EXISTING DRAINAGE AREA MAP

DRN Review completed: MAL 31JUL23  
1. See comments on drainage areas.  
2. See HEC-RAS comments  
3. See HY-8 comments

DGN#	FED. RD. DIV. NO.	STATE	FEDERAL AID PROJECT NO.	HIGHWAY NO.		
CHK DGN#	6	TEXAS	\$PROJNUM\$	CORDOVA RD		
DWG#	DIST.	COUNTY	CONT. NO.	SECT. NO.	JOB NO.	SHEET NO.
CHK DWG#	SAT	GUADALUPE	0915	45	052

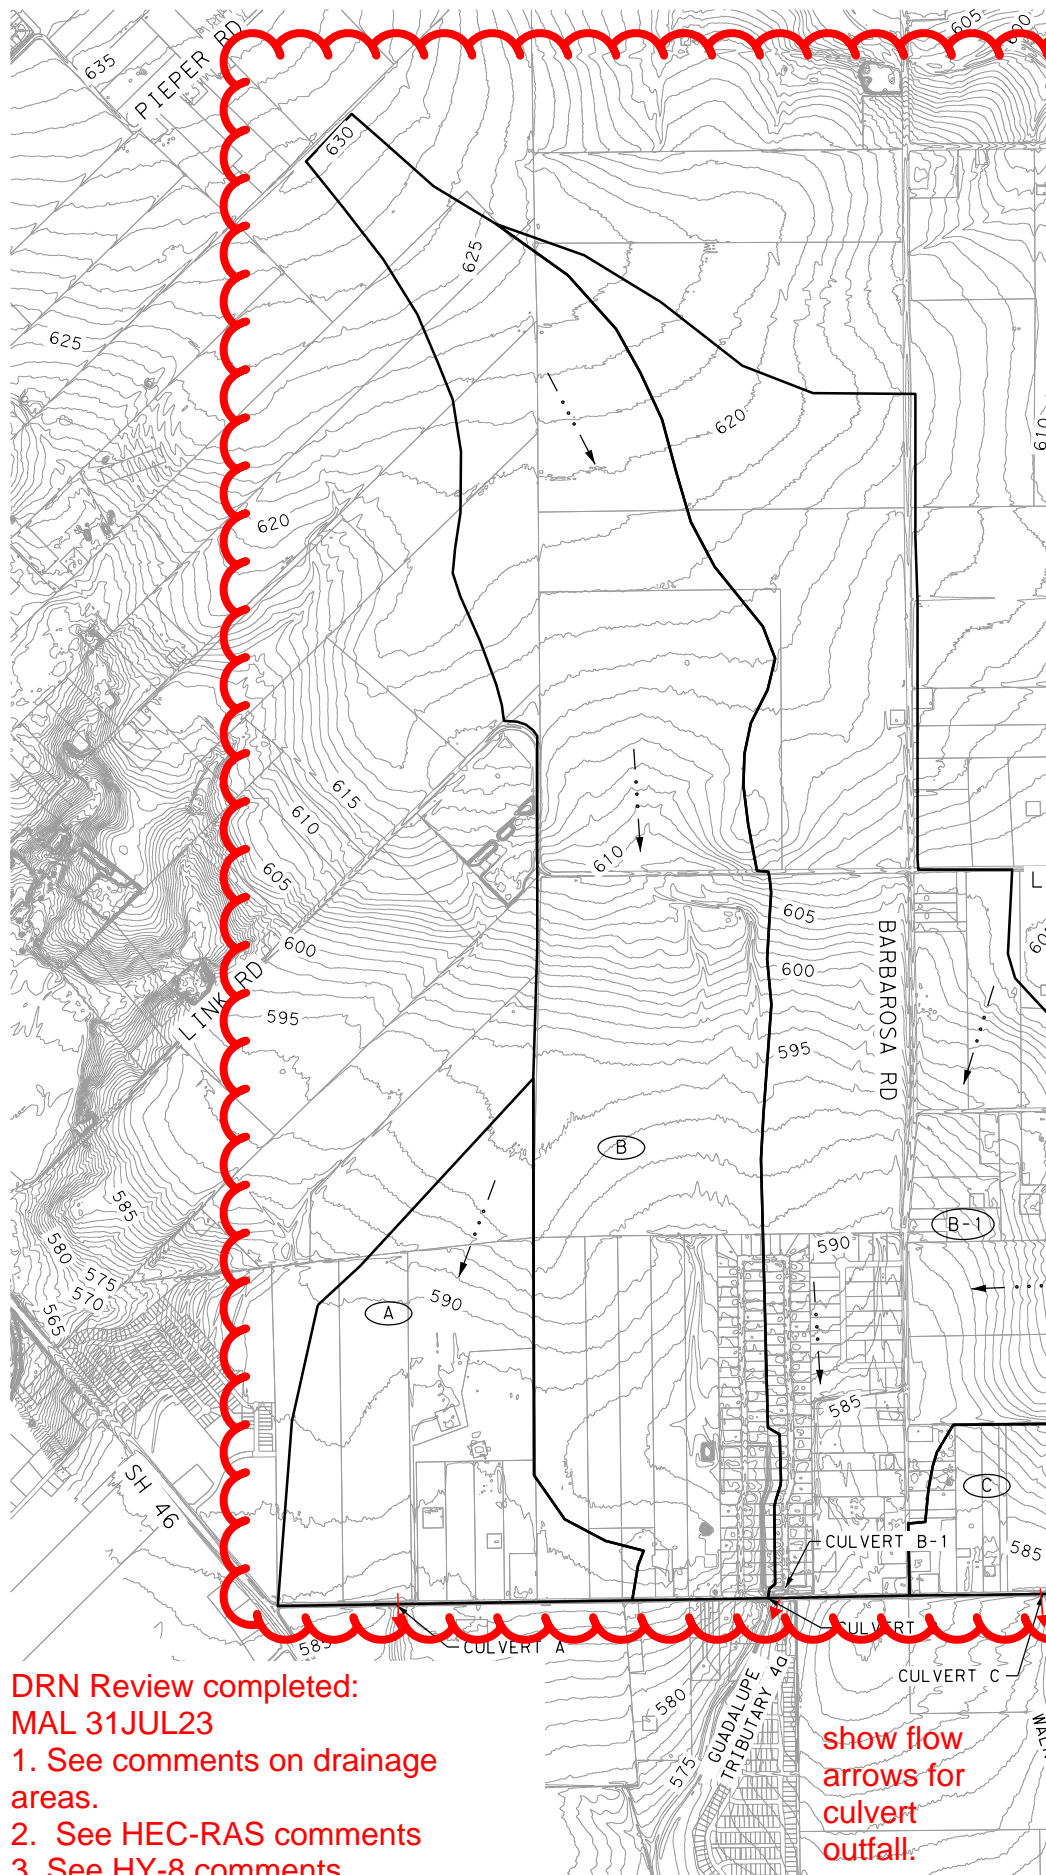
Verify depths. Website shows higher values.

- R.O.W.
- DRAINAGE AREA BOUNDARY
- 850- EXISTING CONTOUR
- Include FPA notification note **Agreed**

Use EBDLKUP-2019, Guadalupe County, Zone 1, PDS Method

show flow arrows for culvert outfall.

Label side streets

Not sure how this outfalls? Please add existing and proposed size to label below Culvert Name. May be extended or to remain. Nice to have an overall knowledge at DAM

What is the difference between existing, proposed and ultimate. What are you using to design the structures?

A new version has been released. Updated to match NOAA Atlas 14, Vol. 11, Ver. 2.

Using the PDS method has not been our practice in the past. We will study this for future submittals.

Agreed. Added.

Adjusted Huber Rd label for greater clarity.

Existing conditions considers present-day conditions, while proposed takes into account the additional impervious cover created by the proposed roadway. Ultimate conditions considers the expected ultimate development of the watershed into single-family residential in addition to the additional roadway pavement.

Agreed. Added existing and proposed structure sizes to DAMs.

## PROPOSED DRAINAGE AREA MAP

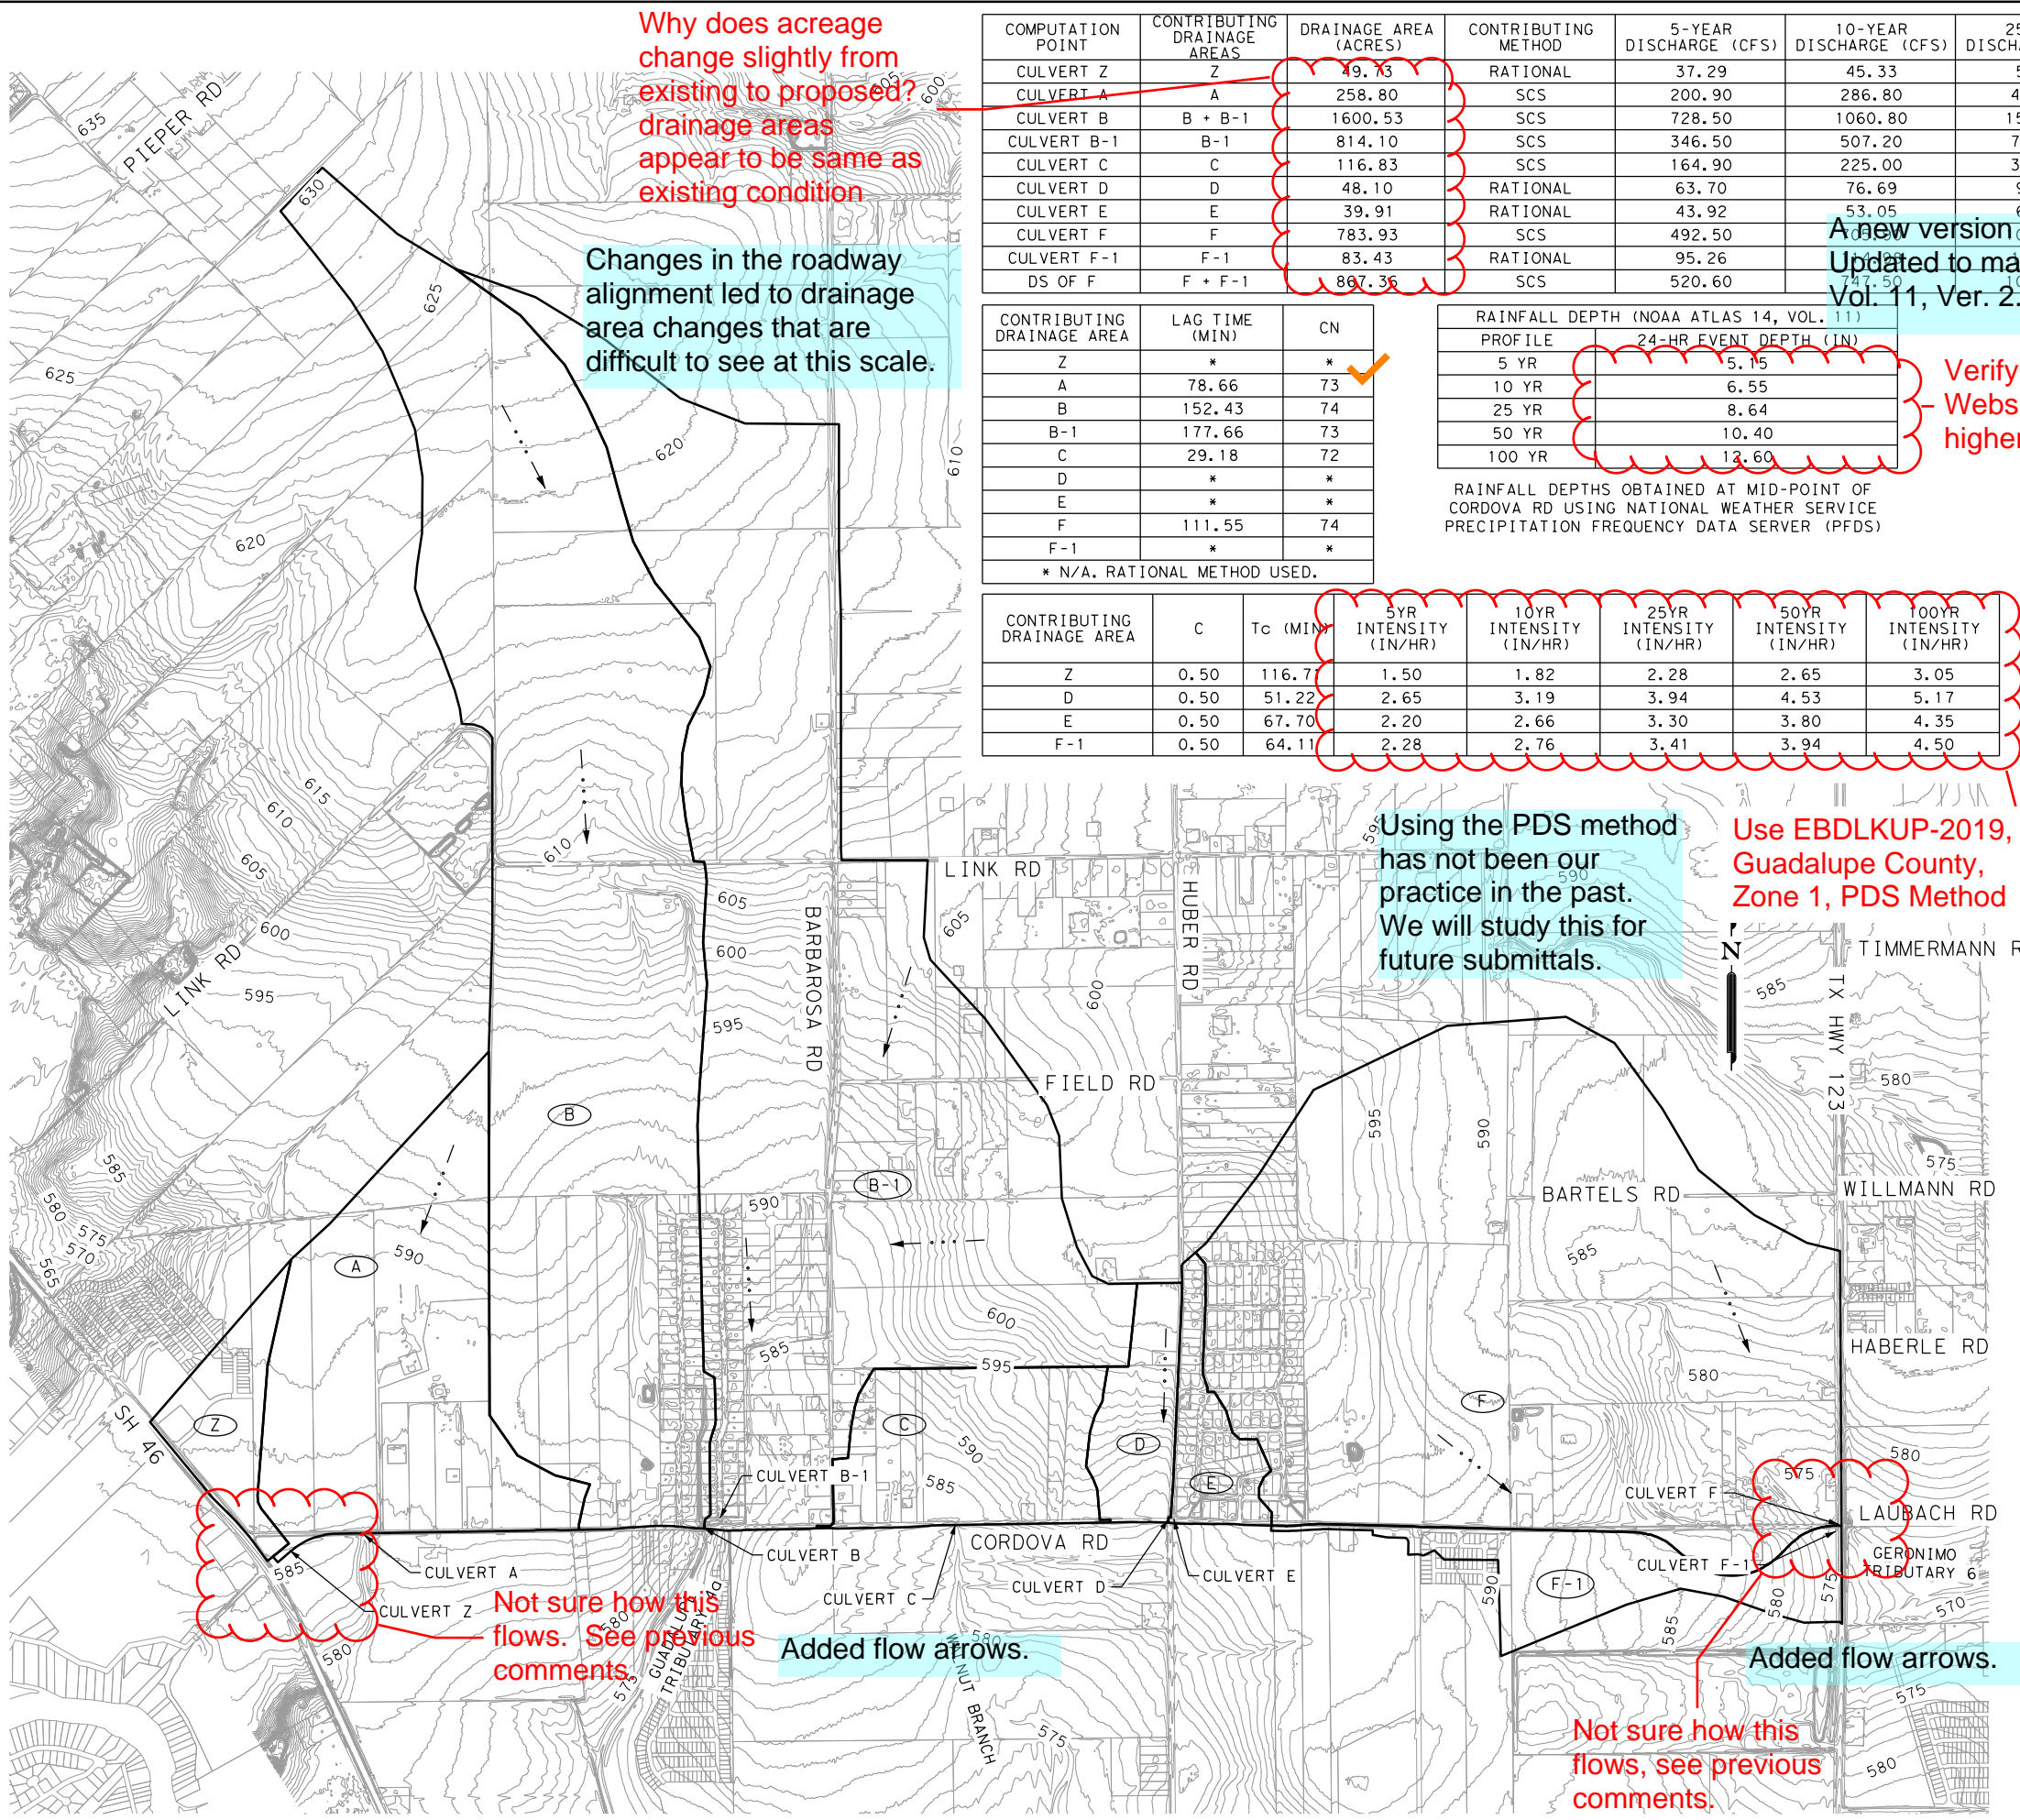
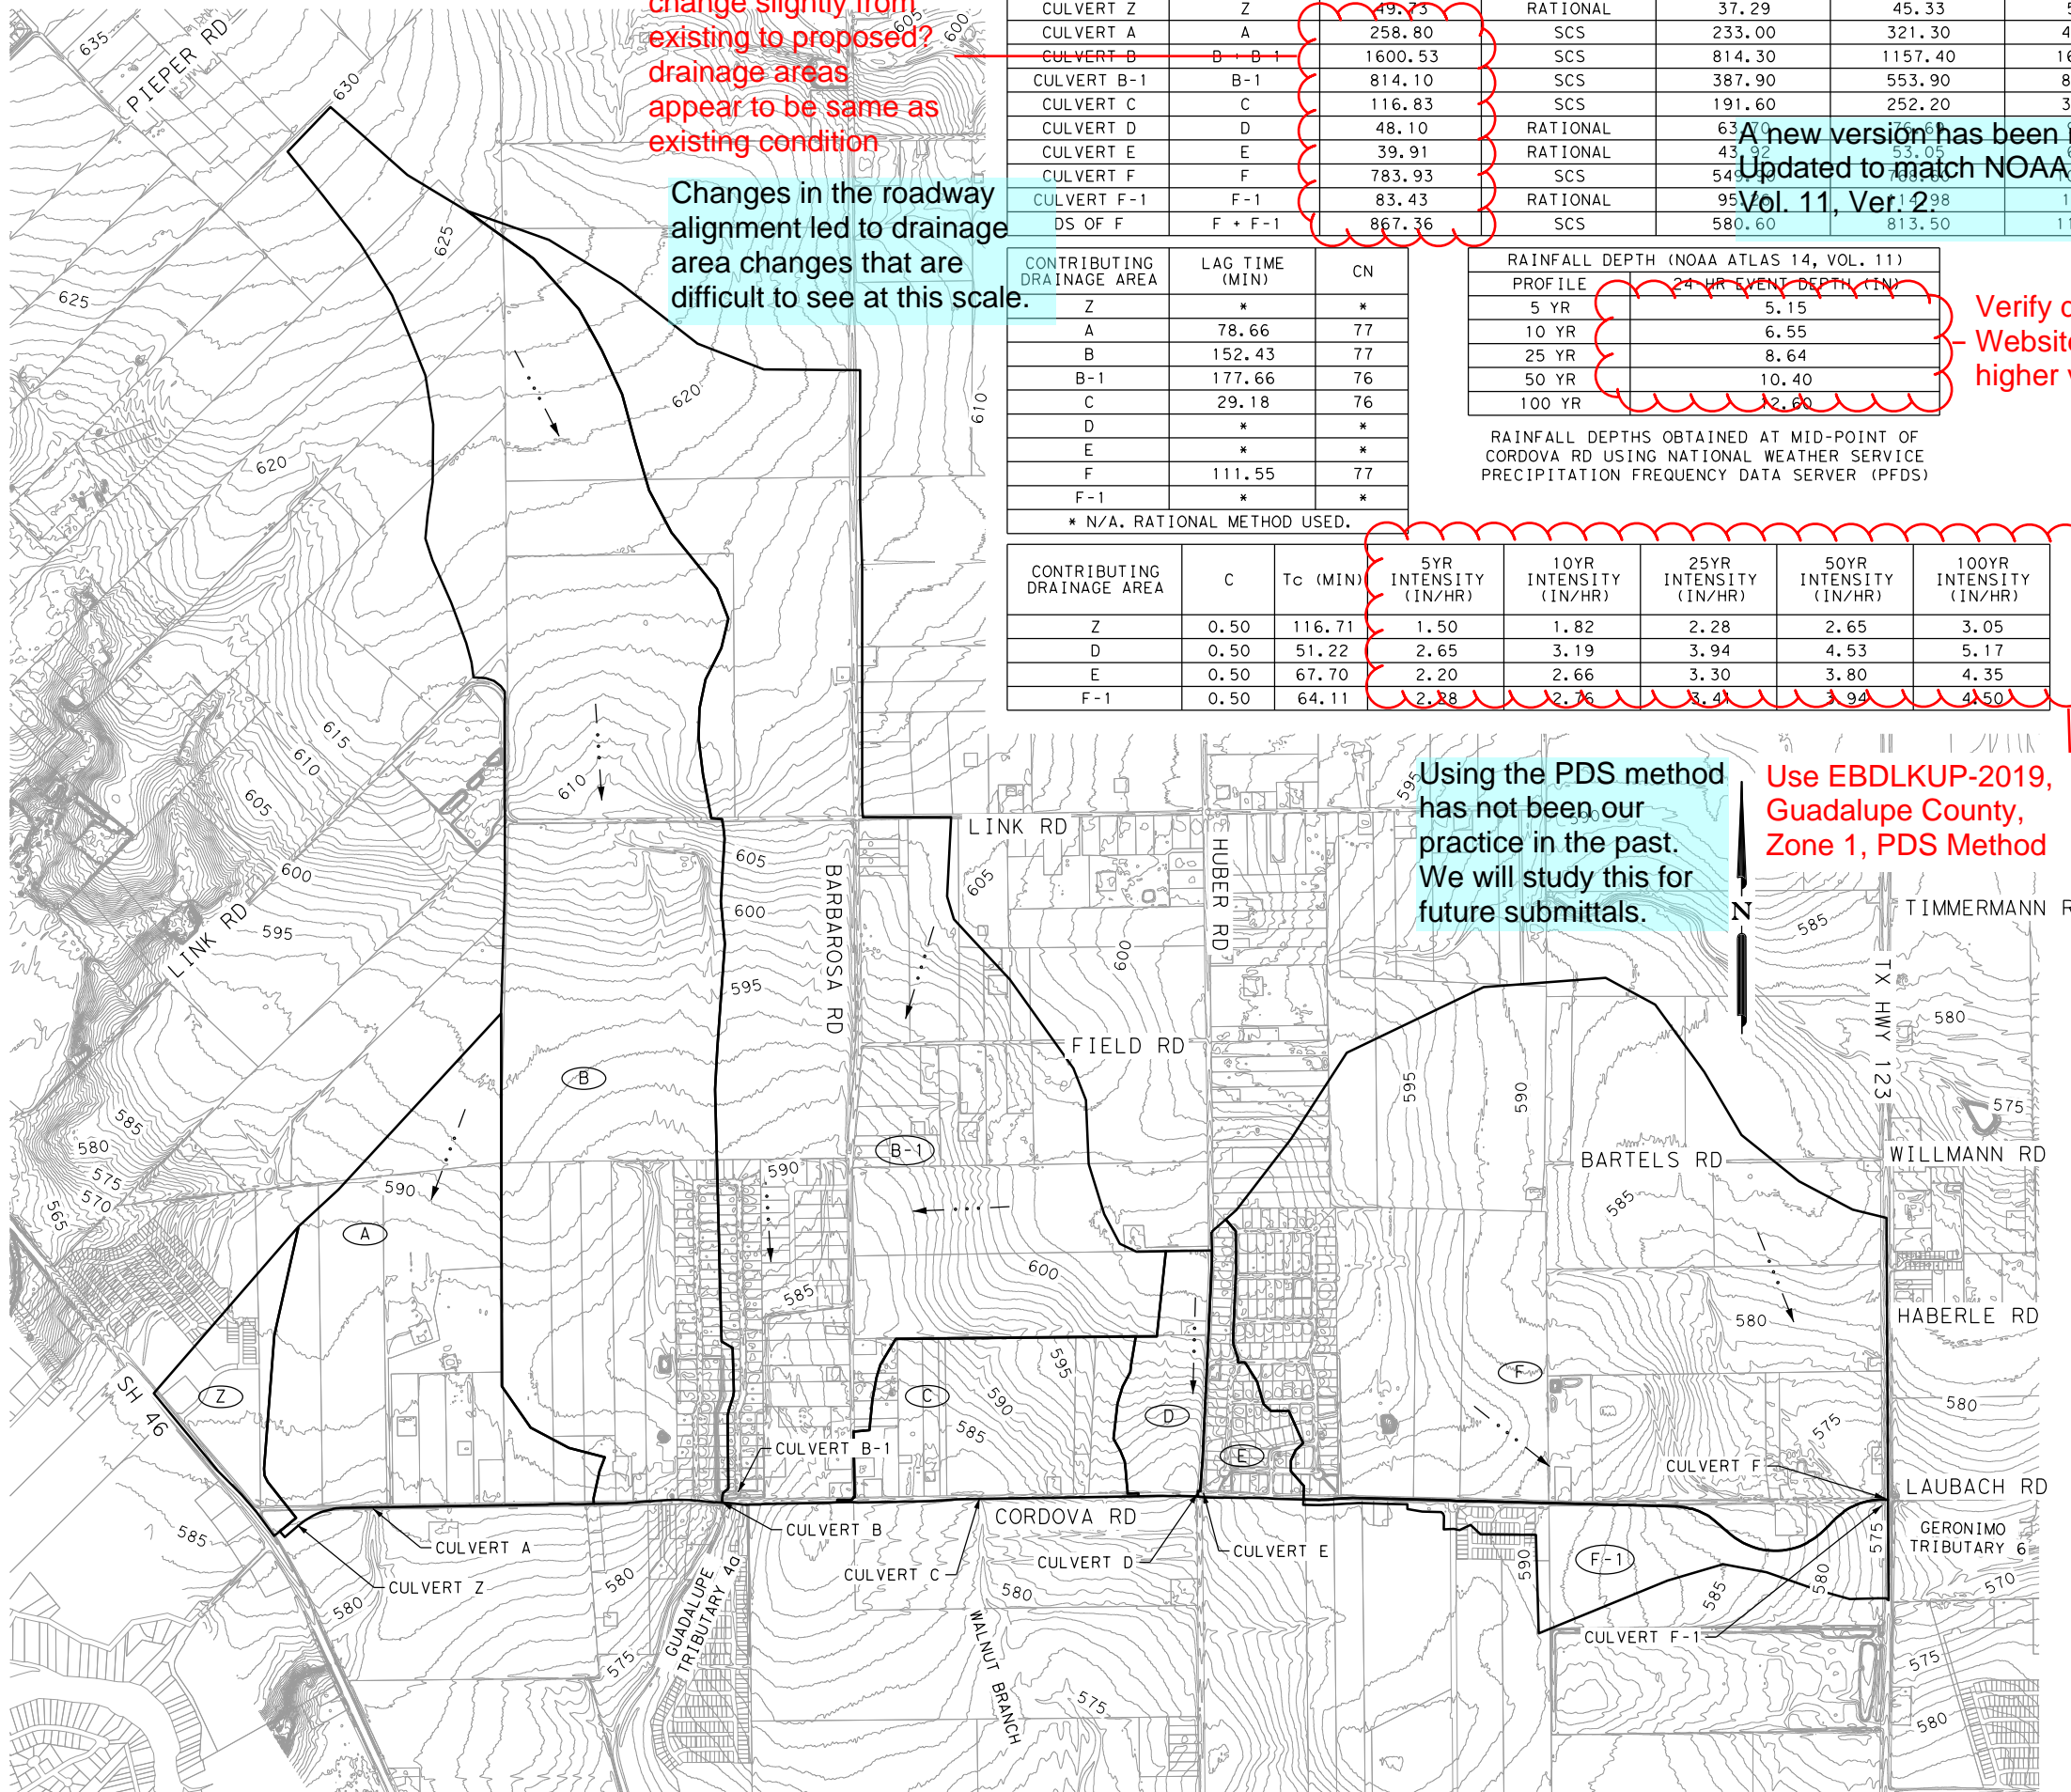
Why does acreage change slightly from existing to proposed? drainage areas appear to be same as existing condition

Verify depths. Website shows higher values.

Use EBDLUP-2019, Guadalupe County, Zone 1, PDS Method

Not sure how this flows. See previous comments.

Not sure how this flows, see previous comments.

Changes in the roadway alignment led to drainage area changes that are difficult to see at this scale.

A new version has been released. Updated to match NOAA Atlas 14, Vol. 11, Ver. 2.

Using the PDS method has not been our practice in the past. We will study this for future submittals.

Added flow arrows.

Added flow arrows.

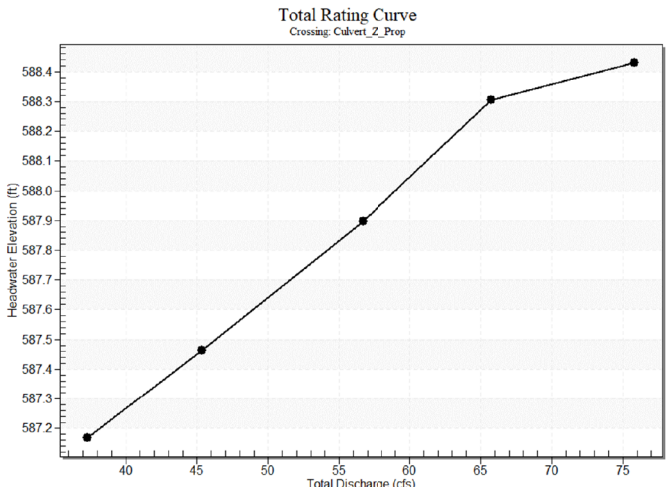
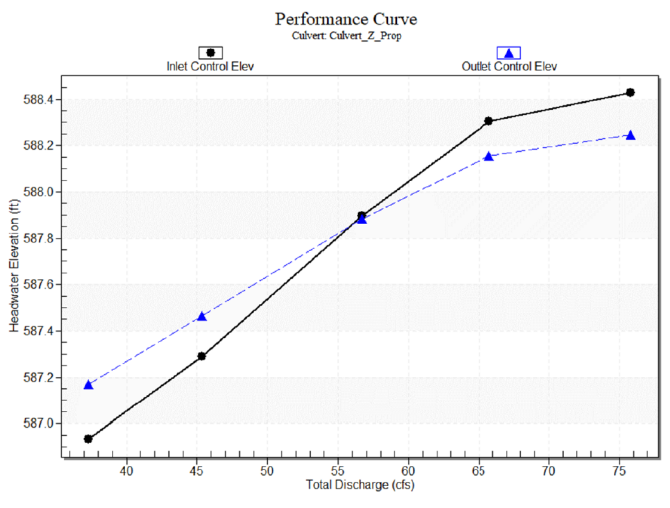
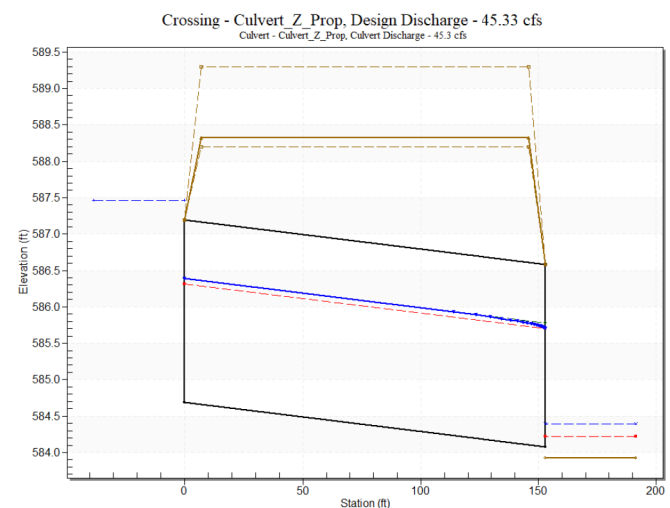
What is channel slope?

Channel is not big enough to convey flow

Why are we proposing pipe other than concrete? Is City ok with this type of pipe?

Once we see the culvert layout and where the elevation of edge of pavement vs the WS10. Need to check you have enough cover for plastic pipe.

No defined channel exists along the eastern side of SH 46 at this new location. The irregular channel data was included in an attempt to capture the flat, open area on the downstream side of the proposed culvert.

Changed to concrete after further design development.
